1981 Corvette: Service Bulletin: Glow Around Wiper Switch Rework Wiper Switch Bezel

Source: Chevrolet Dealer Service Bulletin

Bulletin Number: 81-I-19

Date: January 1981

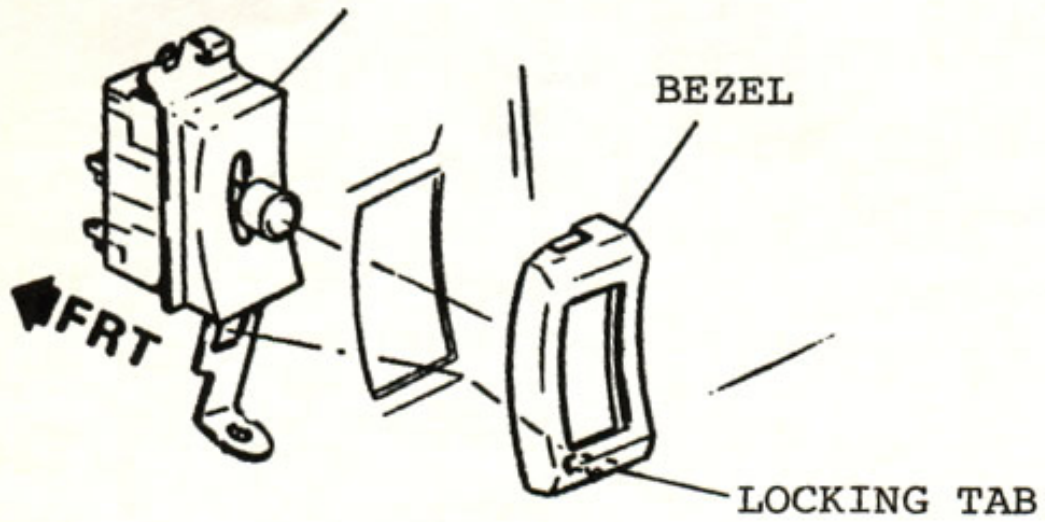
SOME EARLY 1981 CORVETTES WITH SILVER, RED, OR RUST TRIM MAY EXHIBIT A GLOW AT NIGHT AROUND THE WIPER SWITCH BEZEL. IN THESE COLORS, THE BEZEL BASE MATERIAL IS "NATURAL" AND COULD BECOME TRANSLUCENT WITH LIGHTS TURNED ON. THE REMAINING BEZEL COLORS WERE PAINTED OVER A BLACK BASE MATERIAL AND ARE NOT AFFECTED.

THE GLOWING CONDITION CAN BE ELIMINATED BY REPLACING THE ORIGINAL BEZEL WITH P/N 14016216, WHICH IS BLACK AND MUST BE PAINTED TO MATCH TRIM COLOR. THE BEZEL HAS A LOCKING TAB WHICH ENGAGES THE WIPER SWITCH AS ILLUSTRATED ON PAGE 2.
